Modification Recommended Service Note

11713D Attenuator / Switch Driver

Serial Numbers: MY60050105 to MY61410317

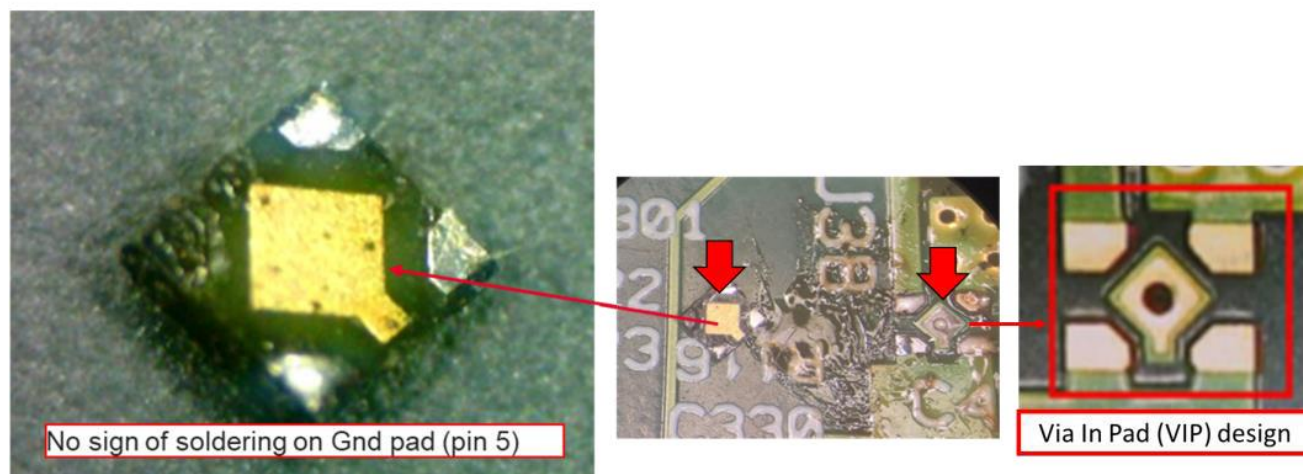
The instrument is unable to boot up and is stuck on the boot-up screen as follows. It is not functioning.

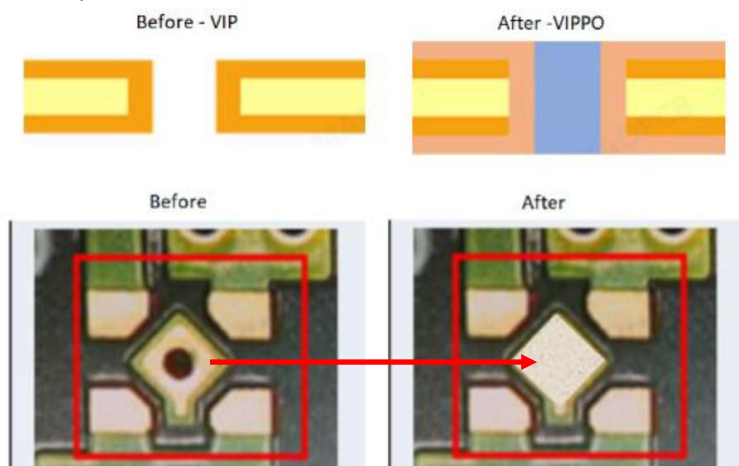
Failure analysis had indicated defective on P0600-63004 board where insufficient solder was observed at 2 locations. The insufficient solder was due to Via in Pad (VIP) where the melted solder had flown to the secondary side of the PCB.

The improvements were made from Via in Pad (VIP) to Via in Pad Plated Over (VIPPO) as per below.

The improved PPMC board have Serial number P06006300423**2413**000007 onwards.

Replace PPMC board P0600-63004 with PPMC board serial number P06006300423**2413**000007 onwards where 13 is the work week and 24 is the year.
